**ADDENDUM NO. 1**

**Alder Avenue  
WORK ORDER: H14978  
AREA: Fontana  
ROAD NO.: 160050 040-050**

## ADDENDUM NO. 1 – ALDER AVENUE

ALDER AVENUE AT VALLEY BOULEVARD TRAFFIC SIGNAL MODIFICATION PLAN FONTANA AREA				
J.L. REF. JL11641	W.O. NO. H14978	SCALE AS SHOWN	SHEET NO. 12	TOTAL SH'TS. 13

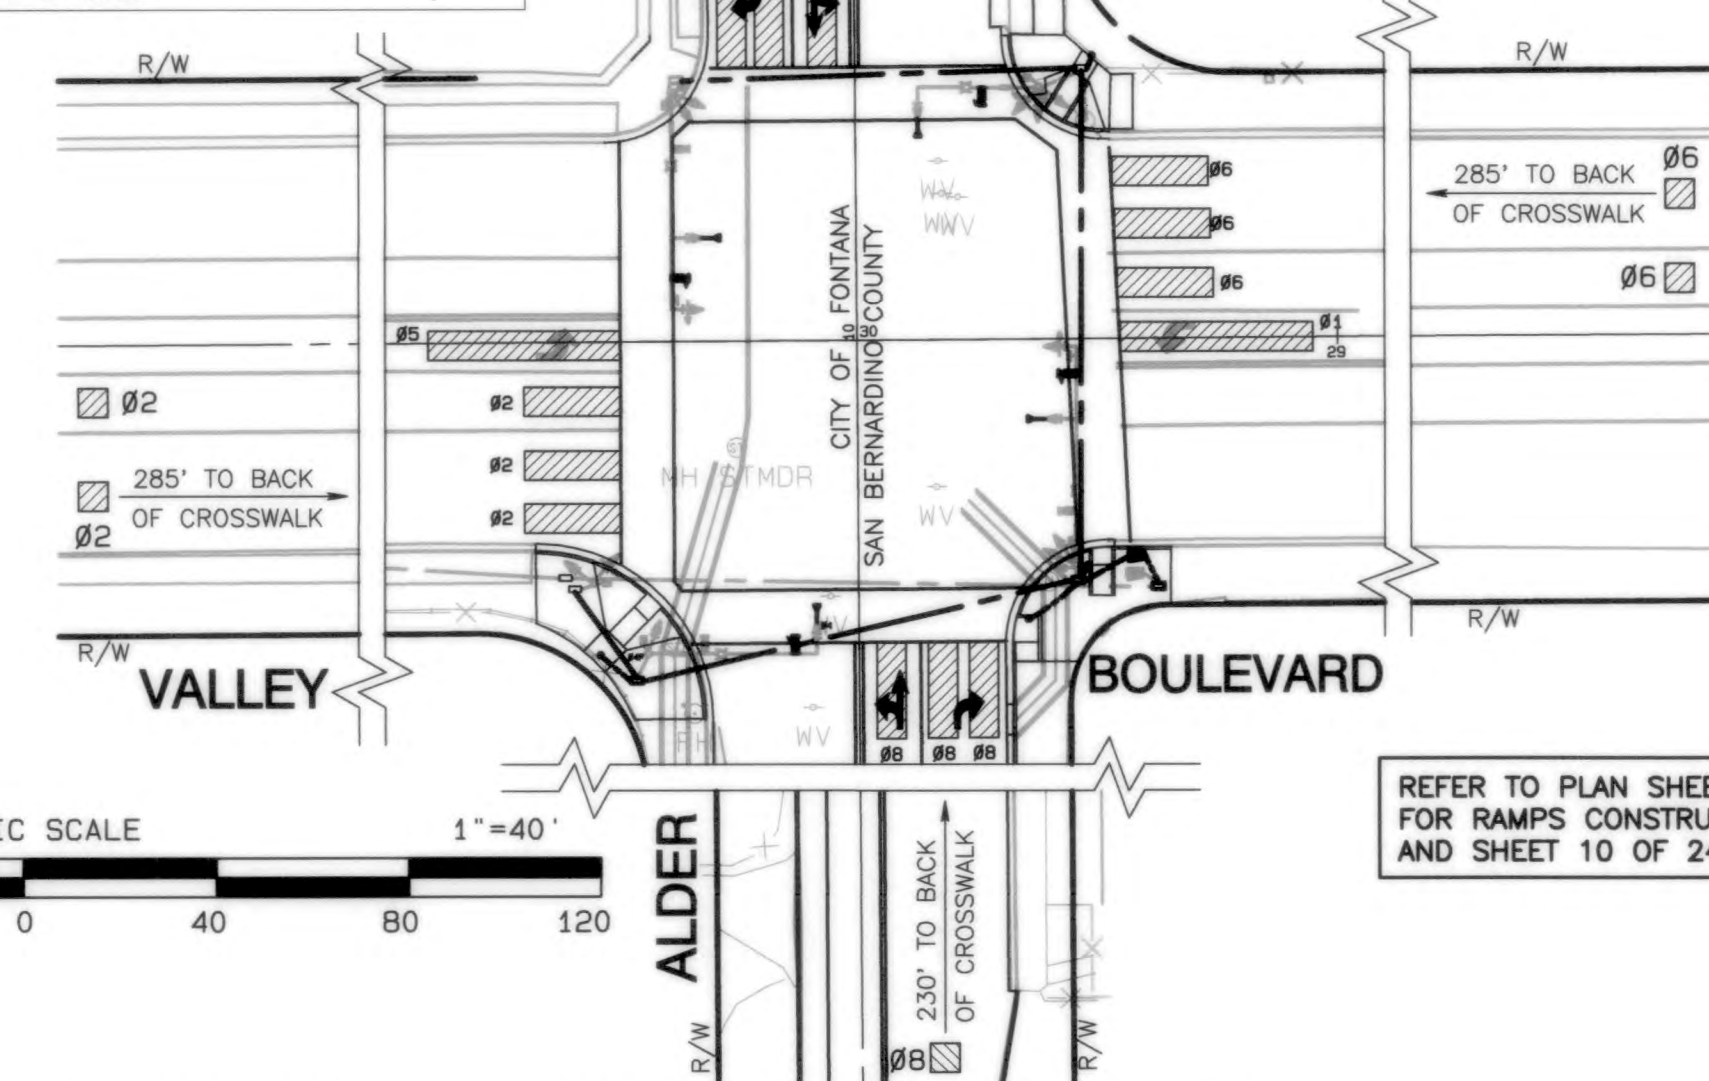
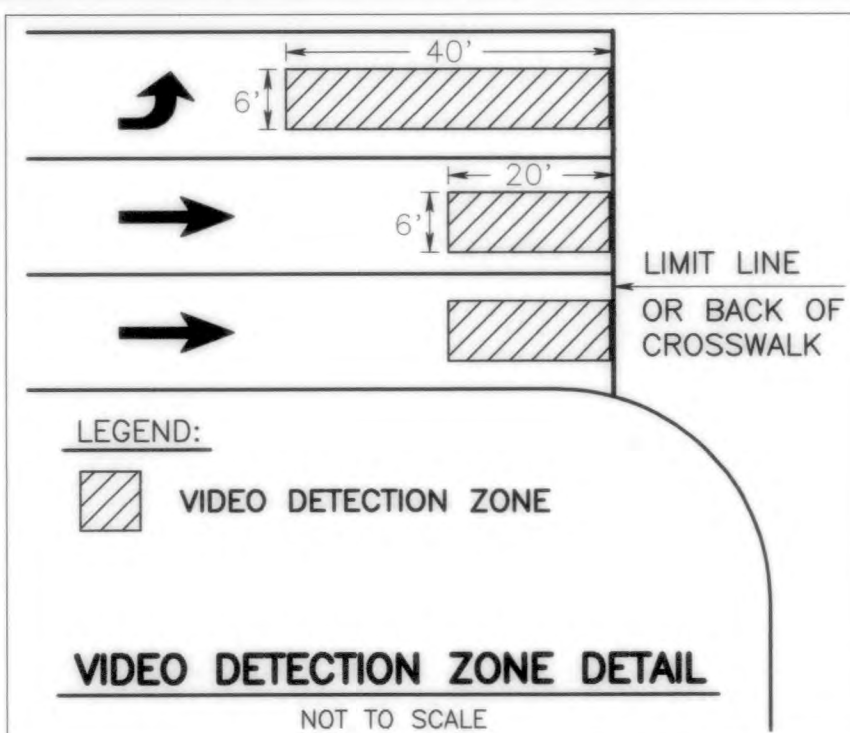
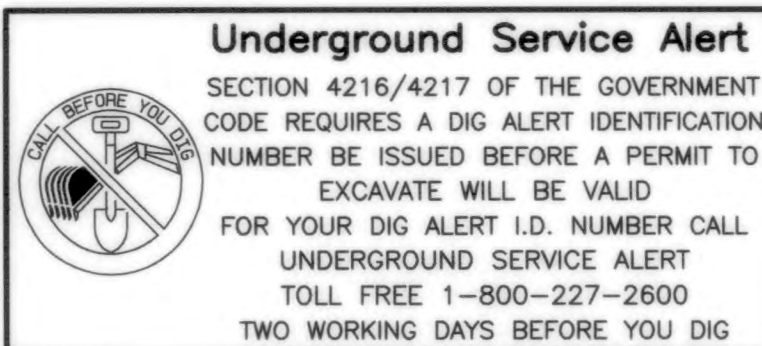
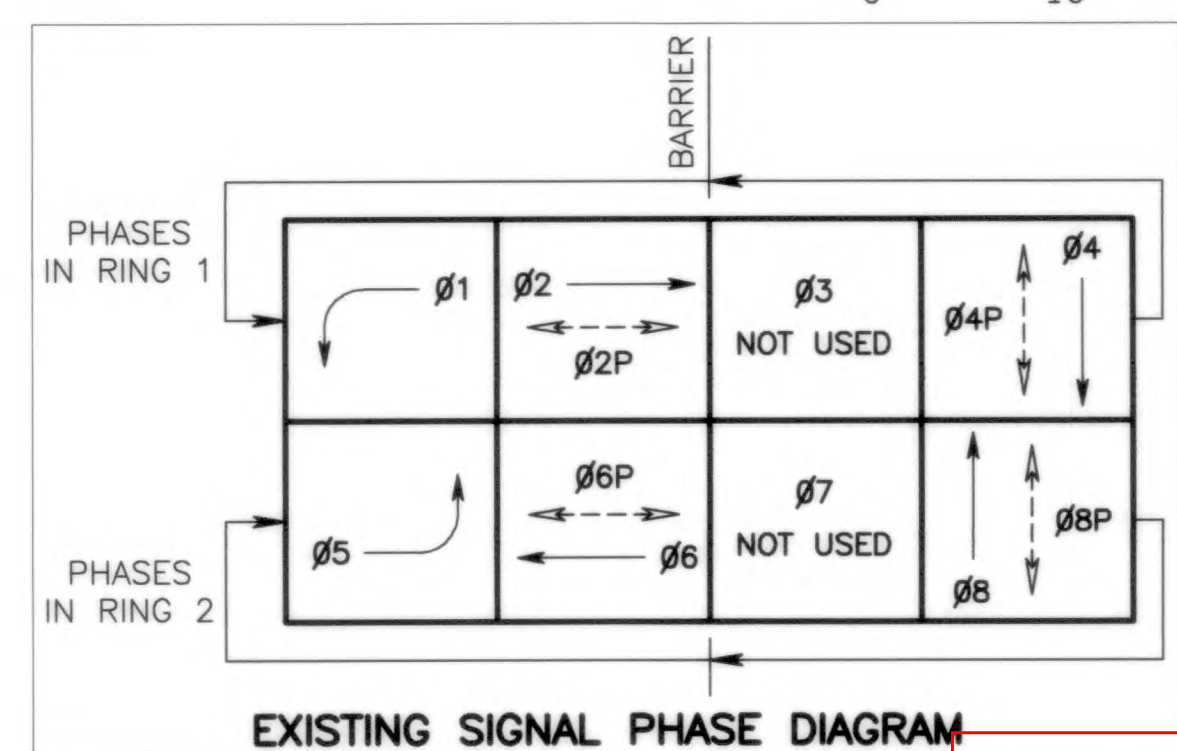
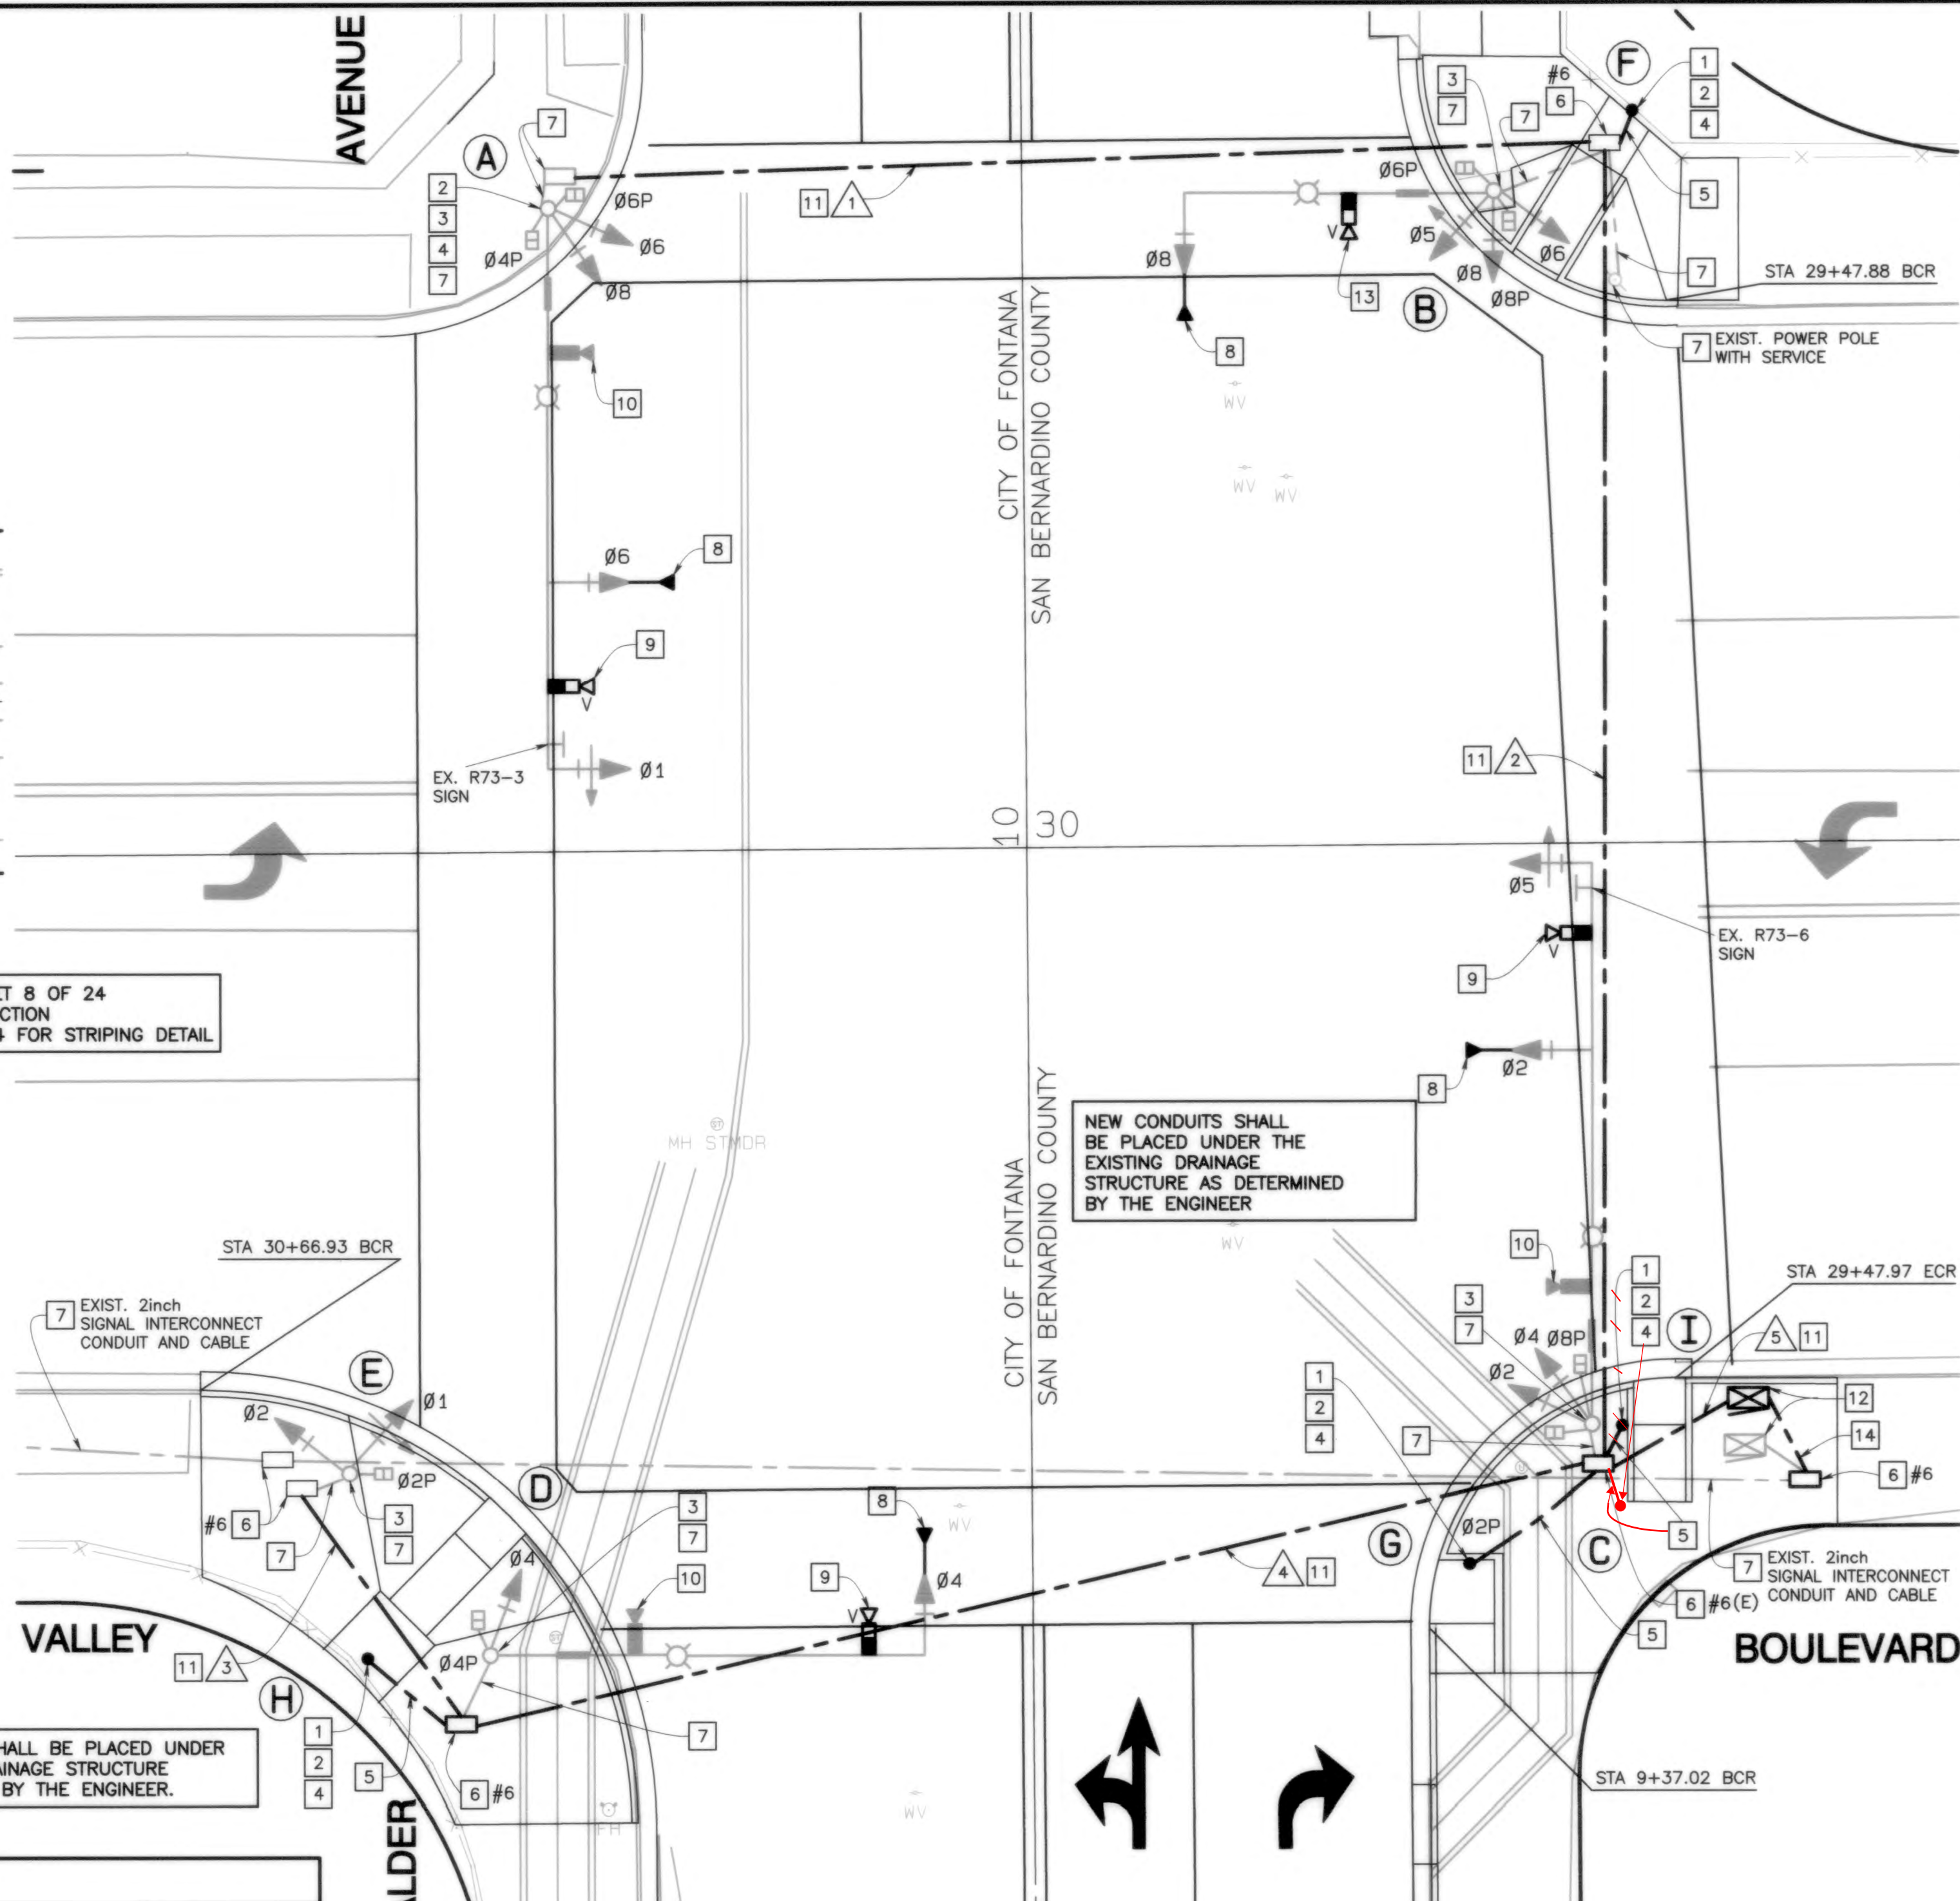
1. Sheet 3 of 13:  
Delete Sheet 3 of 13 and replace with Sheet 3 of 13
2. Sheet 8 of 13:  
Delete Sheet 8 of 13 and replace with Sheet 8 of 13
3. Sheet 12 of 13:  
Delete Sheet 12 of 13 and replace with Sheet 12 of 13
4. Sheet 13 of 13:  
Delete Sheet 13 of 13 and replace with Sheet 13 of 13

1. Revised Sheet 3 of 13, Alder Avenue – Typical Cross Sections;
2. Revised Sheet 8 of 13, Alder Avenue – Curb Return Details;
3. Revised Sheet 12 of 13, Alder Avenue at Valley Boulevard - Traffic Signal Modification Plan;
4. Revised Sheet 13 of 13. No revisions, re-scanned to improve clarity;
5. Revised Bid Item Sheet. Replace proposal page P-3 and P-4 with the attached revised sheet P-3 and P-4.
